Office Action Summary	Application No. 10/802,653	Applicant(s) EISENSCHMID ET AL.	
	Examiner David A. Rogers	Art Unit 2856

DETAILED ACTION

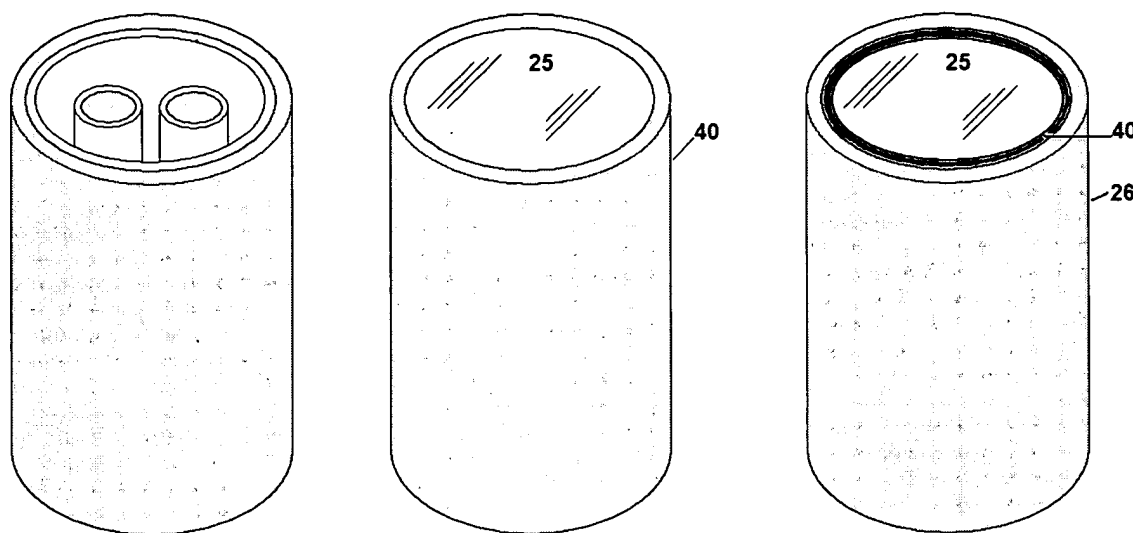
The drawings are objected to because figures 3-7 do not reasonably convey the disclosed structure. For example, figure 3 (reference item 20) should show the wall thickness and the coating thickness as shown in the example below. The individual rods should also be shown in an enlarged view as shown in the examples below. The remaining figures should be amended accordingly.

Corrected drawing sheets in compliance with 37 CFR 1.121(d) are required in reply to the Office action to avoid abandonment of the application. Any amended replacement drawing sheet should include all of the figures appearing on the immediate prior version of the sheet, even if only one figure is being amended. The figure or figure number of an amended drawing should not be labeled as "amended." If a drawing figure is to be canceled, the appropriate figure must be removed from the replacement sheet, and where necessary, the remaining figures must be renumbered and appropriate changes made to the
